WIL – EP No.: EP-313/2008/J
Condition 5.1.1

**Records of Public Open Space Reprovisioning /
Restoration**

Re-provisioning of LCSD Facilities

LCSD Detailed Design Presentation: Part 2

A. Sai Woo Lane Playground

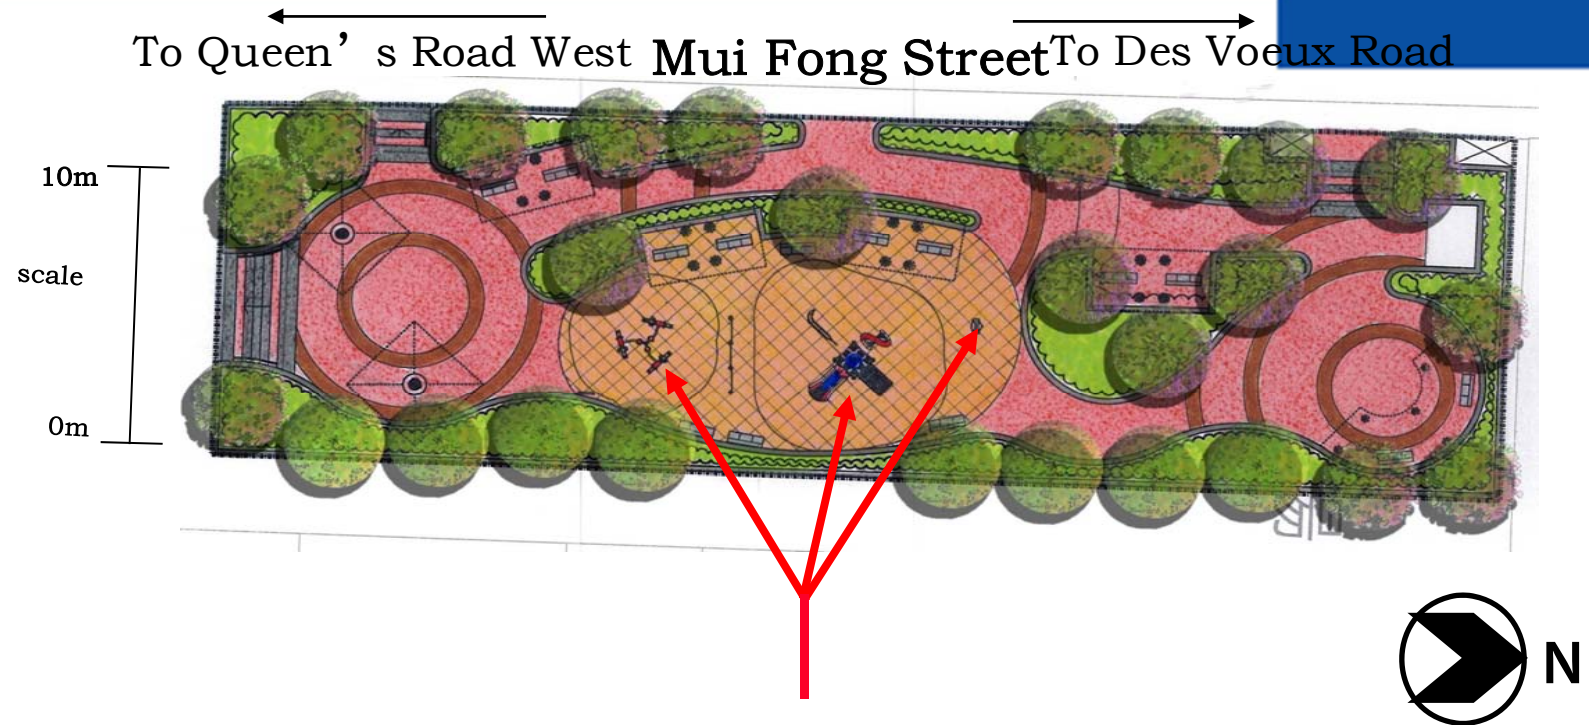
2.1	Area A: Sai Woo Lane Playground MTRC requested LCSD’s written confirmation on extent of the revised design		LCSD

5.	Individual re-provisioned areas	
5.1	<p>Area A: Sai Woo Lane Playground</p> <p>LCSD agreed addition of benches outside the soccer pitch, and revision to the</p>	LCSD

layout of the soccer pitch, toilets and changing room. LCSD would promptly issue a confirmation letter to MTRC, together with the specific requirements and revised planting proposal.

B. Mui Fong Street Children's Playground

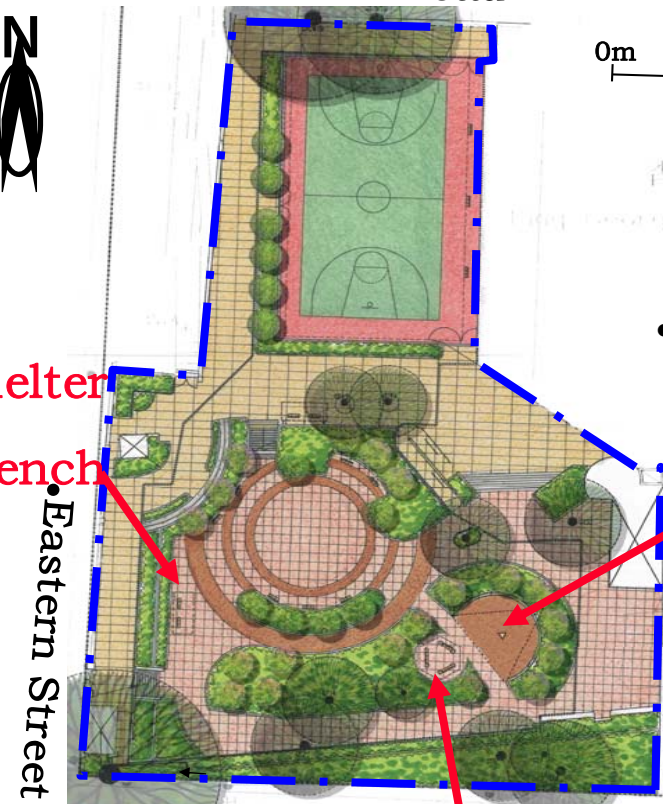
NOTES OF MEETING		
	change of football pitch and layout of toilets/changing room.	
2.2	<p>Area B: Mui Fong Street Children's Playground</p> <p>LCSD agreed in principle to MTRC's extended duration of using the site subject to no adverse comment from C&WDC. MTRC undertook to lobby DC, in particular, DC chairman, vice-chairman and local councillor for endorsing the extension .</p>	MTRC

5.2	<p>Area B: Mui Fong Street Children's Playground</p> <p>LCSD stated that it was not necessary to disclose the application of extension (to Jan 2015) for occupying this area in the forthcoming C&WDC meeting.</p>	Noted

C. King George V Memorial Park, HK • Hospital Road

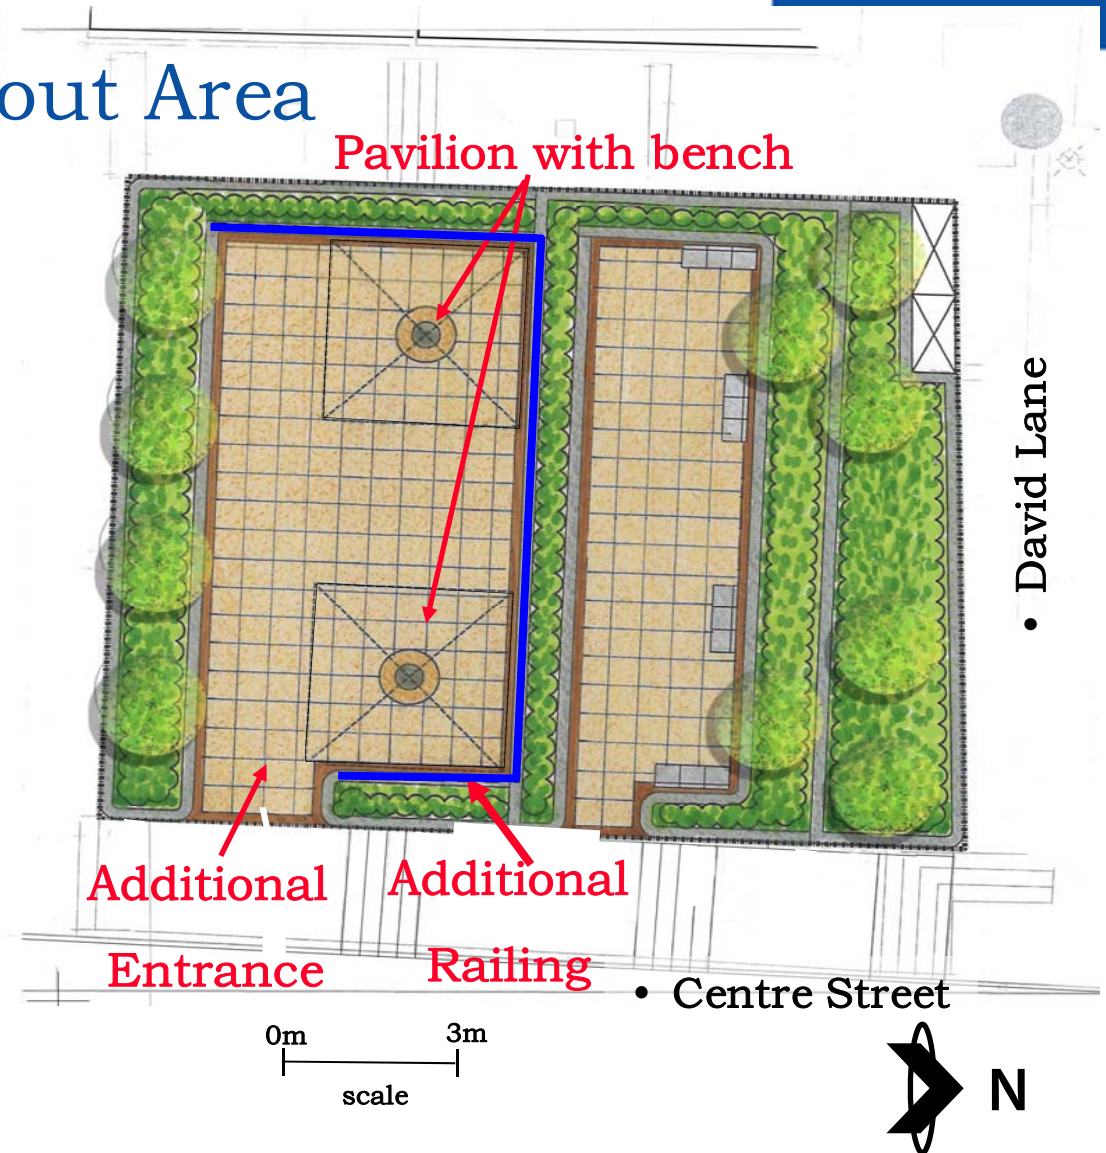
2.3	<p>Area C: Portion of King George V Memorial Park</p> <p>Same kind of facilities would be re-provided, but upgraded to meet prevailing standard; and hence the site occupation period might need to be extended for the works. LCSD had no adverse comment in this regard.</p>	Noted

5.3	<p>Area C: Portion of King George V Memorial Park</p> <p>LCSD noted the possible extension of handover date until January 2015.</p> <p>Regarding some local councillors' proposed addition of facilities at the KGV Memorial Park, LCSD opined that their requests of addition of elderly facilities and shelter for sitting benches were easier to achieve. But for the addition of an access ramp at High Street, LCSD made the following remarks :</p> <ul style="list-style-type: none"> • Technical feasibility study should be conducted if the ramp would be located at or close to the existing retaining wall. • There is an existing Old and Valuable Tree No. CW16 close to the proposed ramp location. If the ramp is constructed away from the OVT for sake of tree protection, the level difference would be increased and certain landscaped area and trees on the retaining wall might be affected. • The impact to the overall work programme of the WIL project should be carefully assessed. <p>LCSD asked MTRC to critically consider the request of C&WDC and to prepare drawings and photos to show the current site conditions for presentation to the C&WDC members for further discussion.</p>	Noted Noted MTRC

F. Ki Ling Lane Children's Playground

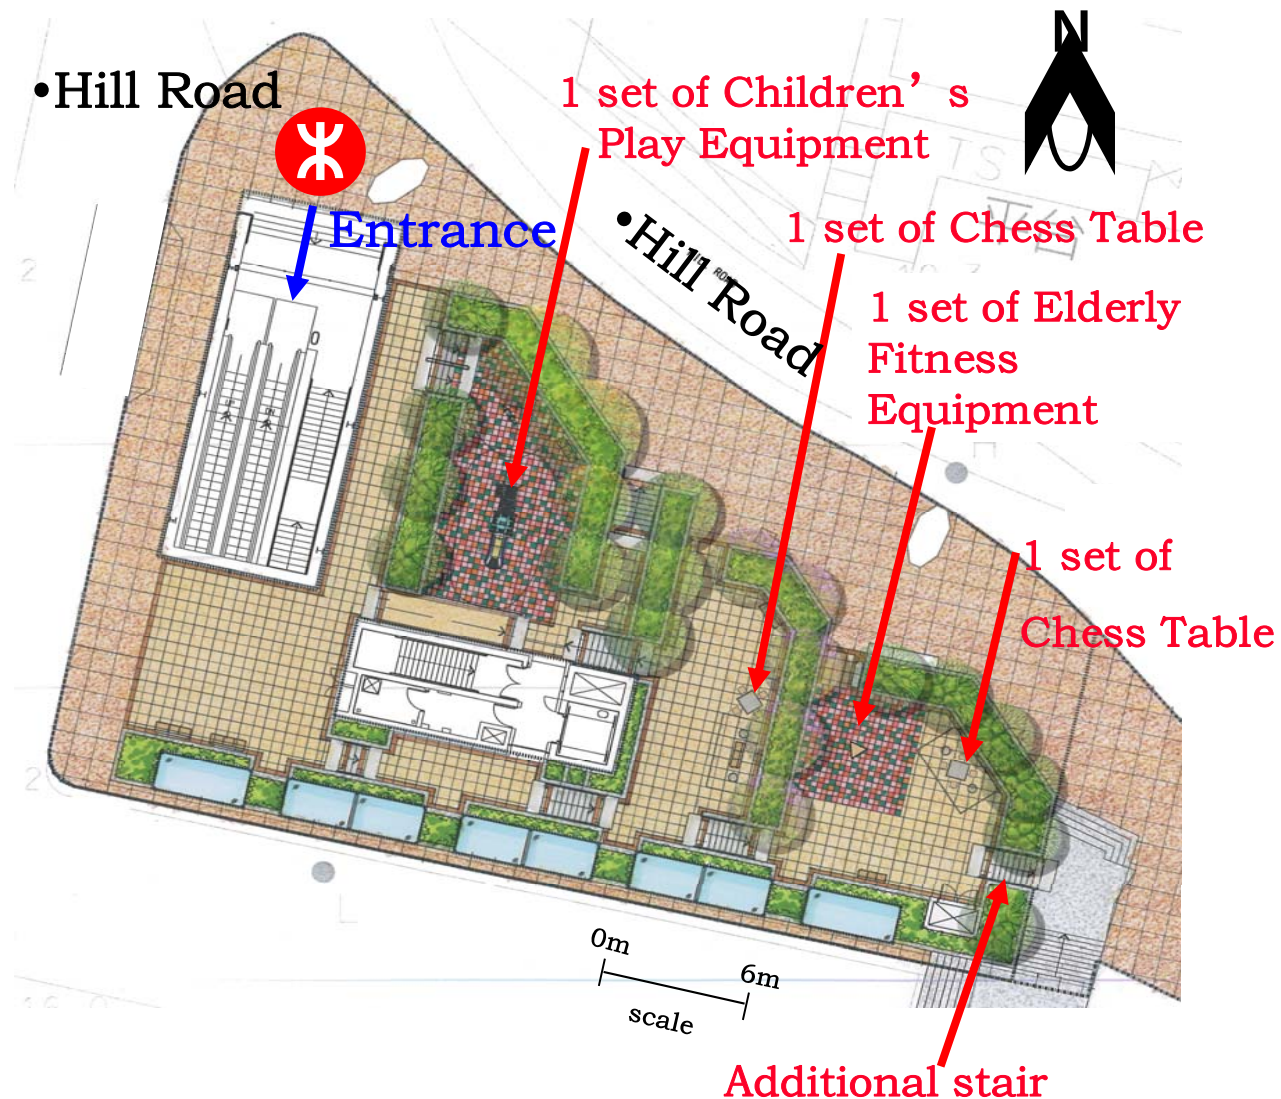
2.4	<p>Area D: Centre Street Sitting-Out Area at David Lane</p> <p>No comment.</p>	
2.5	<p>Area F: Ki Ling Lane Children's Playground</p> <p>LCSD asked for more "wooden horses" in the re-provisioning, at least 3 sets.</p>	MTRC

K. Old Kennedy Town Swimming Pool

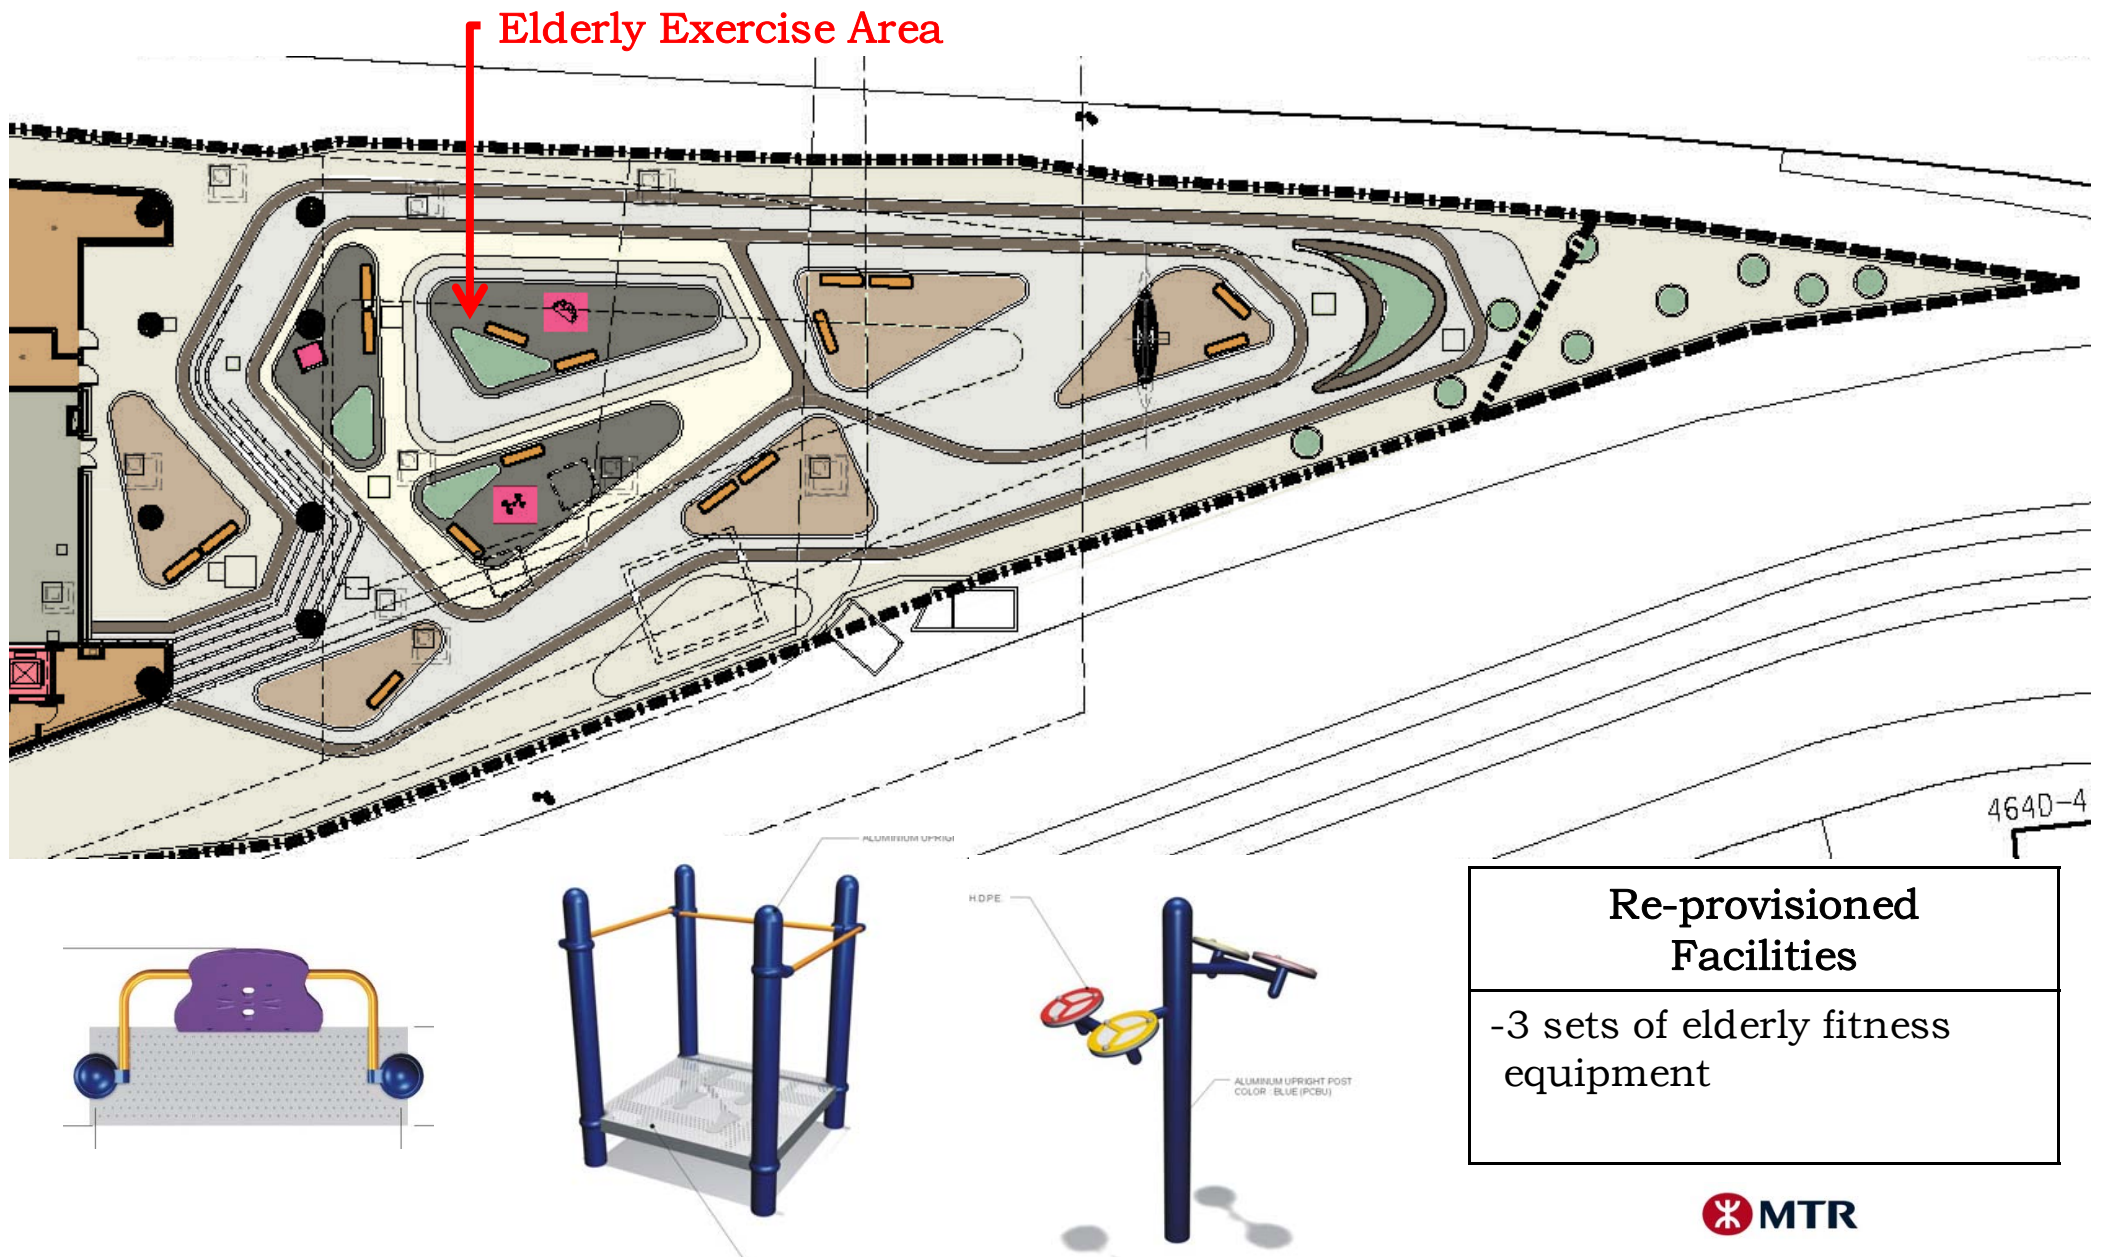
2.9	<p>Area K: Ex-Kennedy Town Swimming Pool</p> <p>The tentative date of handing over this area was 31 August 2014.</p>	Noted
	<p>LCSD requested the provision of bollards at the demarcation line at entrances facing GMB stop for preventing street hawkers or other carts from entering into the LCSD's garden.</p>	MTRC
	<p>MTRC would provide a maintenance matrix to delineate maintenance responsibilities for MTRC and various government departments in different</p>	MTRC
